PROCLAMATION CALLING A SPECIAL MEETING OF THE BERKELEY CITY COUNCIL

1. ZAB Appeal: 1155-1173 Hearst Avenue

On February 2, 2016, Hearst Avenue Cottages, LLC and Rhoades Planning Group (“Applicants”) submitted a Use Permit application for a project that requested to merge the two lots, substantially rehabilitate the existing seven dwelling units, and construct eleven additional units employing State Density Bonus Law, for a total of 18 units. Due to the provision of Density Bonus Law requiring replacement of units under rent control, which, according to the Applicants, rendered the project infeasible, the Applicants chose to revise the project in response to comments received by the ZAB during the project hearing on September 28, 2017.

Figure 1:
Approximate Exploratory Boring Locations

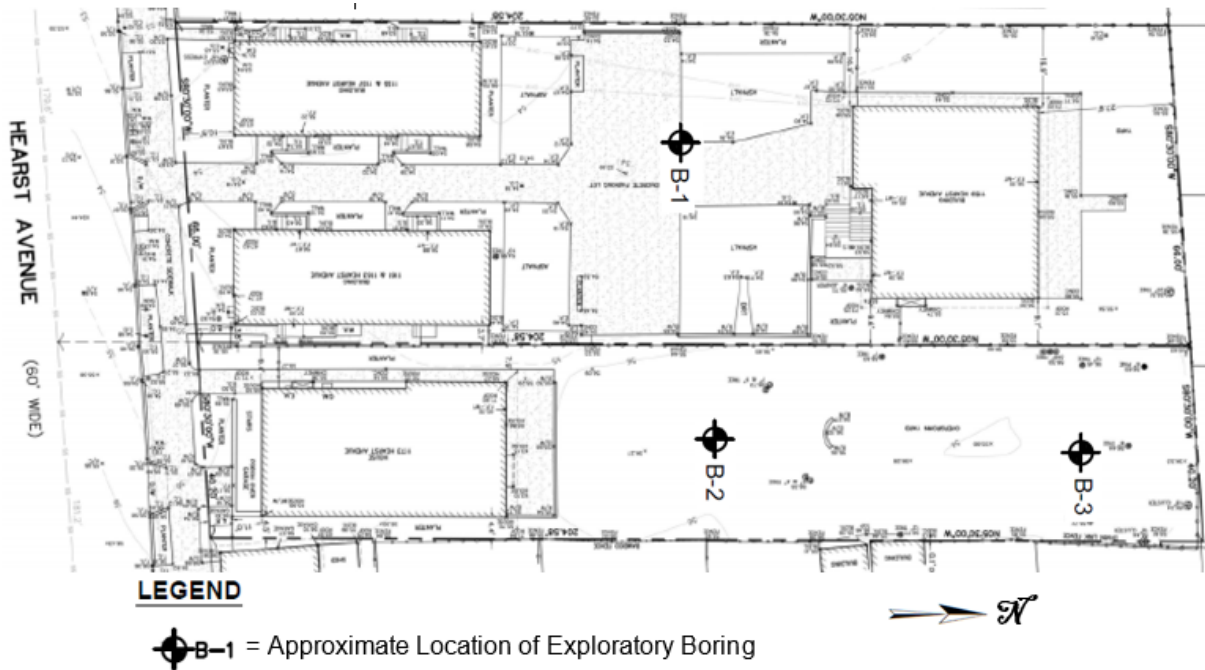
Response B2: The Geotechnical Consultant drilled three borings on the subject site in August of 2018. The two borings (B-2 and B-3) made along the eastern portion of the site, reached a depth of 11.5 feet and neither encountered groundwater. The third boring near the western boundary (B-1) was drilled to a depth of 26.5 feet. Groundwater was encountered at a depth of about 15.5 and rose to about 10 feet one hour after drilling. See Figure 1 below.

5 foot thick layer of low permeability clays, which hydraulically separates the overlying perched water from the regional groundwater below. During the winter rainy season, infiltrated rainfall or local runoff saturates the surface soil layer and induces surface ponding due to the impermeability of the clay strata, and irrespective of the ground water level below.

The Applicant’s consultant team acknowledges that groundwater levels may rise during winter months. The Geotechnical Consultant has, therefore, recommended that a groundwater height of five feet below the ground surface be used in project design, which is the depth that the California Geological Survey has mapped as the historic high groundwater level for the subject site.

Figure 2:
Load Bearing Diagram for Hearst Gardens Soil Profile with Site Plan Key Below

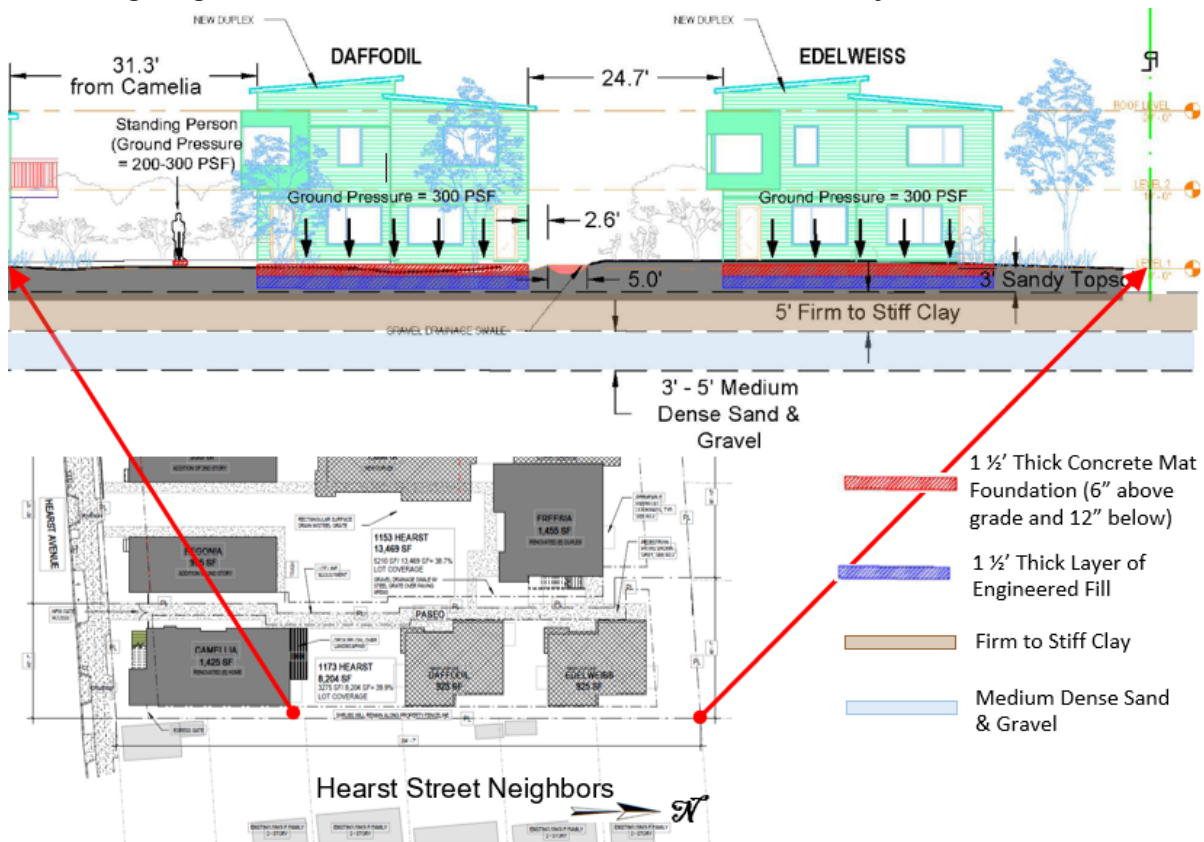
Response B3: Members of the public have posited that the impact of the proposed development’s placement of very shallow and discontinuous engineered fill and mat foundations would act as a dam to the groundwater flow on the project site, similar to a dam across an above-ground stream or river. This is inaccurate. A surface dam creates an impermeable barrier across the entire width of a stream channel and its floodplain, and must seamlessly tie-into similarly impermeable formations to either side of the

Figure 2 below depicts the actual conditions that would occur along the eastern edge of the site where two new buildings are proposed. As shown, the new building foundations would not span the entire site as a dam would. Rather, openings of roughly 15 feet would exist to either side of these buildings. More importantly, the vertical extents of the engineered fill that would be placed beneath the mat foundations and the overlying mat foundations would not extend to more than three feet below the existing ground. This depth matches that of the surface soil layer, which is underlain by 3-5 feet of firm clay. Such clay layers are typically considered non-water bearing soil strata and do not readily transmit water vertically, either from the surface via infiltration or from the subsurface via rising groundwater tables.

Groundwater that occurs under the site flows in a roughly east-west direction and will preferentially favor the coarser materials that underlie the clay layer. At this depth and at the ground pressures exerted by the buildings, approximately 300 pounds per square foot (psf), no effects from the mat foundations would be transmitted that could alter the hydraulic conductivity of the water bearing layer. Groundwater would continue to flow freely under the shallow foundations within the dense sand and gravel layer beneath the clay. As is also shown in Figure 2, the ground pressure exerted by a standing person of moderate stature (200-300 psf) is not substantially different from the pressure exerted by the mat foundations.

**Figure 3:
Drainage Outlet Channel Design**

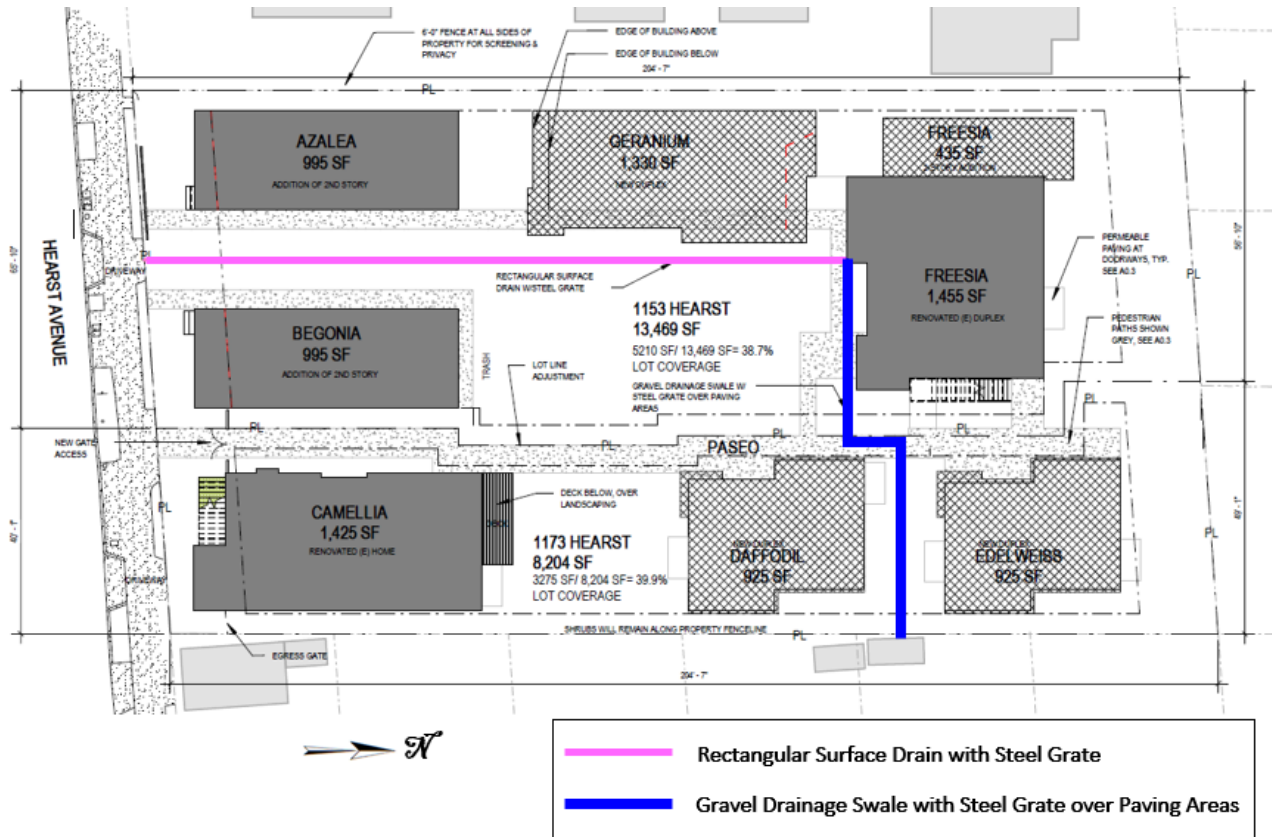
Response B5: The Appellants have stated that the change in permeable paving on the project site would result in decreased infiltration, thereby resulting in additional runoff (i.e. flooding) on adjacent properties and the city's drainage system. They have posited that the development would impede the infiltration capacity of the topographic depression existing on the central portion of the site, which acts as a rain garden.² Rain gardens are usually constructed on sites to retain and pond stormwater runoff which can then prolong the opportunity for infiltration into the soil profile

In addition to the surface swale and outlet drainage channel within the new project driveway—the alignments of which are also shown in the Figure 3—the Hydrology Consultant evaluated the volumetric increase in

site stormwater runoff for the post-project condition. The estimated increase of 5.6 cubic feet, or 119 gallons, could be absorbed by incorporating a rain barrel (cistern) into the project design. The Hydrology Consultant recommended that both of the new buildings along the eastern portion of the site be fitted with 150-200 gallon rain cisterns. The inclusion of rain barrels would control the incremental increase in post-development runoff to the storm drain system during rain events.

Recognizing the existing impediment to more efficient drainage along the Curtis Street backyard areas, the Hydrology Consultant developed a project drainage solution that would provide for construction of a surface drainage channel to capture and drain-off roughly 50% of the ponded water during higher recurrence interval (i.e. more intense) rainstorms. The layout of the new drainage channel is below in Figure 3. While this feature will not completely eliminate the existing backyard nuisance flooding for those properties, it will improve the existing drainage from those lots and reduce the depth of flooding experienced by the west side Curtis Street properties. The project drainage system would provide an improvement over existing conditions.

Figure 2: GIS Creek Layer on Area Including Project Site

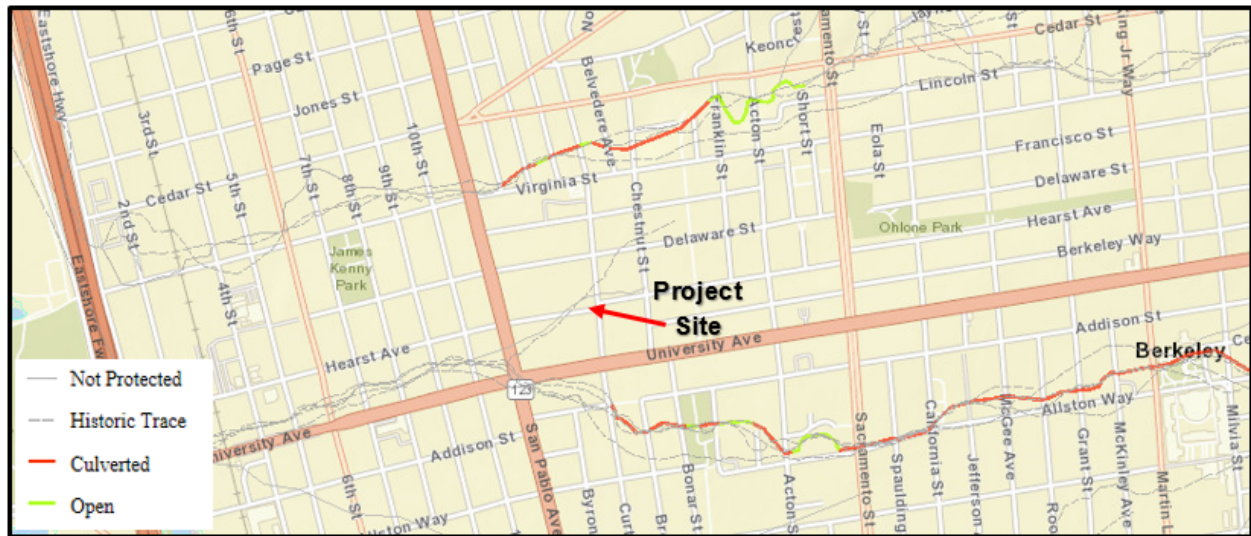
invoking the exception may establish an unusual circumstance “[b]y showing that the project has some feature that distinguishes it from others in the exempt class, such as its size or location.” *Id.* at 1105. Though the project area is above a former creek and though there is evidence of flooding in the backyards of the neighborhood, this is not unique to this project, or in fact to this neighborhood. In questioning different members of Public Works field staff, several areas of the City were listed as experiencing seasonal flooding including the northwest corner of University and San Pablo Avenues; Derby Street near Martin Luther King Jr. Way; Derby Street between Shattuck and Telegraph Avenues; and the area around Malcolm X Elementary School south of Ashby Avenue and west of the Ashby BART station, among others. It is not a coincidence that all these areas are over either historic traces of streams or underground creek beds, labeled “Not Protected” on the City’s GIS maps (<http://cobmapv2/planning/>). As can be seen in Figure 2 below, which represents a small portion of the City, underground and historic traces of streams striate the city running from east to west. Ponding and flooding conditions vary, but are not uncommon or otherwise unusual on the numerous properties overlaying these hydrologic features.

Additionally, in response to the Appellant’s point, the Public Works Engineer has stated in the record that although the Urban Creek Council—a Bay Area non-profit organization working to preserve, protect, and restore urban streams and their riparian habitats (urbancreeks.org)—may have classified this area as “filled wetlands” and as “seismically unstable and subject to liquefaction,” that is not the

Figure 3: Earthquake Zones of Required Investigation (USGS)

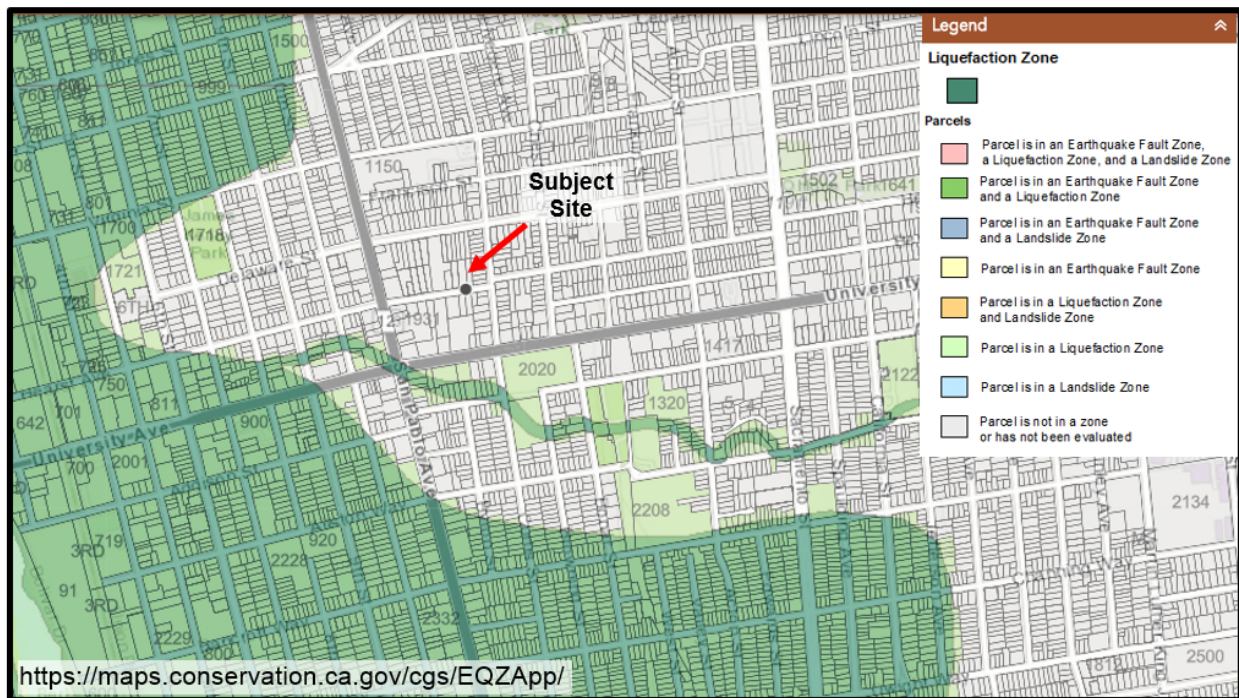
viewpoint of Public Works staff or the U.S. Geological Survey (USGS), who have not designated this area as a site with high potential for liquefaction. See figure 3 below.

Available information belies the Appellant’s claim that an unusual circumstance exists as the project does not have some feature, such as size or location, which distinguishes it from others in the exempt class. Accordingly, the project is exempt from CEQA under the Class 32 In-Fill categorical exemption.

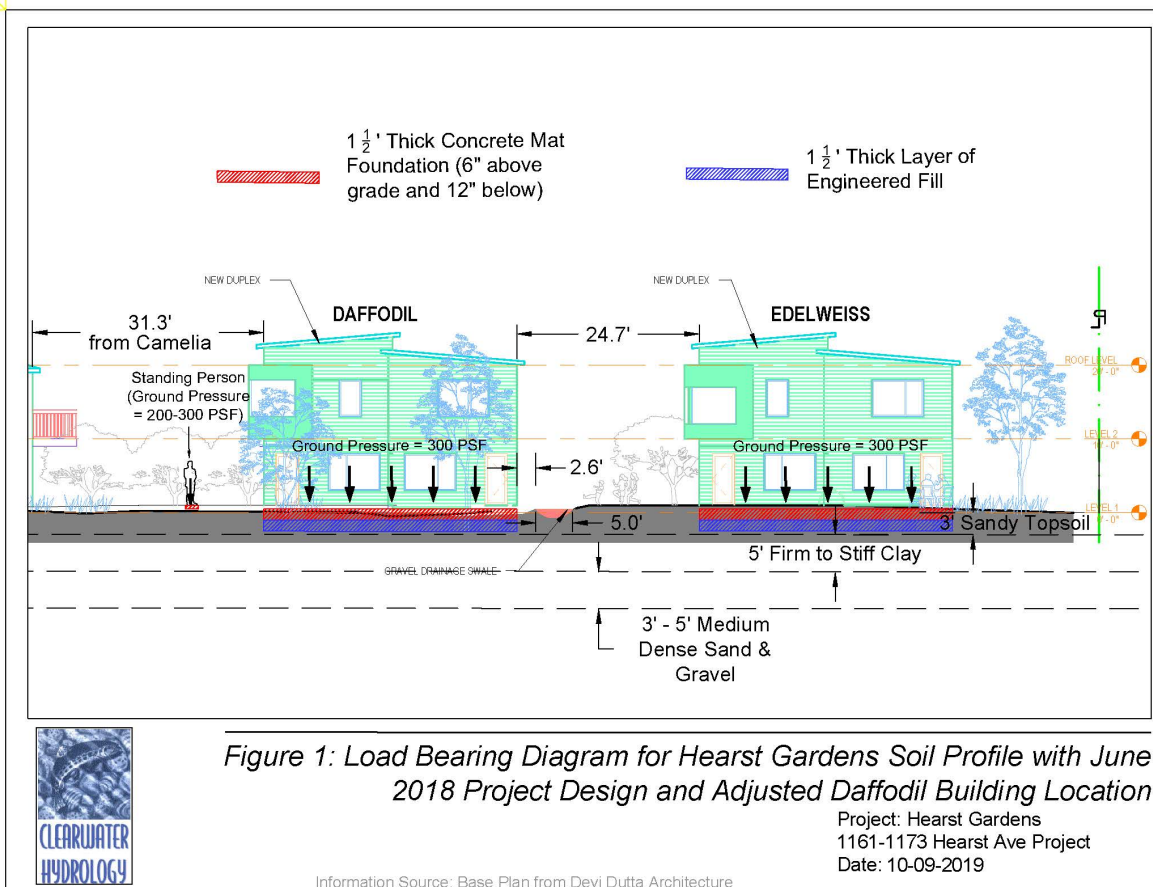
Figure 1 below depicts the actual conditions that would occur along the eastern edge of the site where two new buildings are proposed. The soil profile layers delineated in the Figure were derived from three soil borings drilled by Kropp & Associates in the summer of 2018.

Figure 1 is scaled, and reference to the scale bar shows that the new building foundations do not span the entire site as a single structure, as a dam would. Rather, openings of roughly 15 ft. will exist to either side of these buildings. More importantly, the vertical extents of the engineered fill that would be placed beneath the mat foundations and the overlying mat foundations would not extend to more than 3 ft. below the existing ground. As shown, this depth matches that of the surface soil layer, which is underlain by 3-5 feet of firm clay. Such clay layers are typically considered non-water bearing soil strata and do not readily transmit water vertically, either from the surface via infiltration or from the subsurface via rising groundwater tables.

mat foundations would be transmitted that could alter the hydraulic conductivity of the water bearing layer. Groundwater would continue to flow freely under the shallow foundations within the dense sand and gravel layer beneath the clay. As is also shown in Figure 1, the ground pressure exerted by a standing person of moderate stature (200-300 psf) is not substantially different from the pressure exerted by the mat foundations.

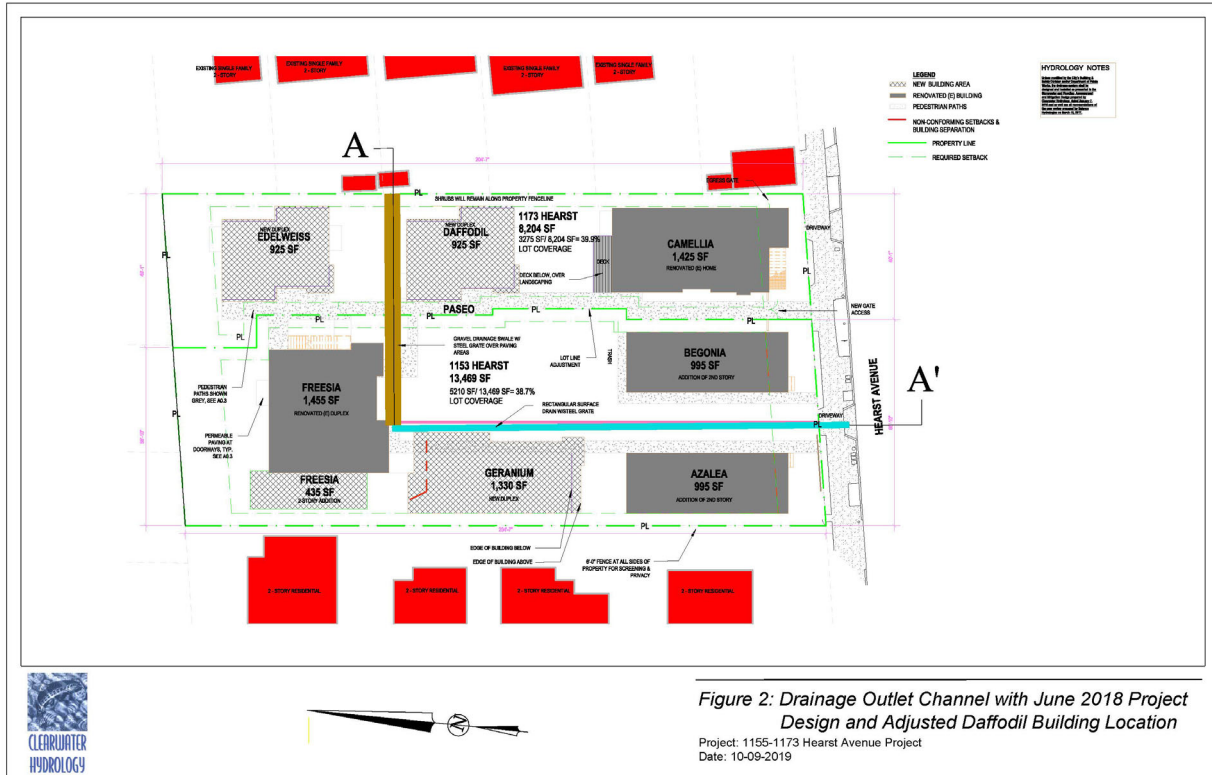
The CH design recognized this existing impediment to more efficient drainage along the Curtis Street backyard areas and developed a solution that would provide for construction of a surface drainage channel to capture and drain-off roughly 50% of the ponded water during higher

recurrence interval (i.e. more intense) rainstorms. The layout of the new drainage channel is below in Figure 2. While this feature will not completely eliminate the existing backyard nuisance flooding for those properties, it will improve the existing drainage from those lots and reduce the depth of flooding experienced by the west side Curtis Street properties.

In addition to the surface swale and outlet drainage channel within the new project driveway- the alignments of which are also shown in the Figure 2, CH evaluated the volumetric increase in site stormwater runoff for the post-project condition. The estimated increase of 5.6 cubic feet, or 119 gallons could be mitigated by incorporating a rain barrel (cistern) into the project design. To add a safety factor, we recommend that both of the new buildings along the eastern portion of the site be fitted with 150-200 gal. rain cisterns.
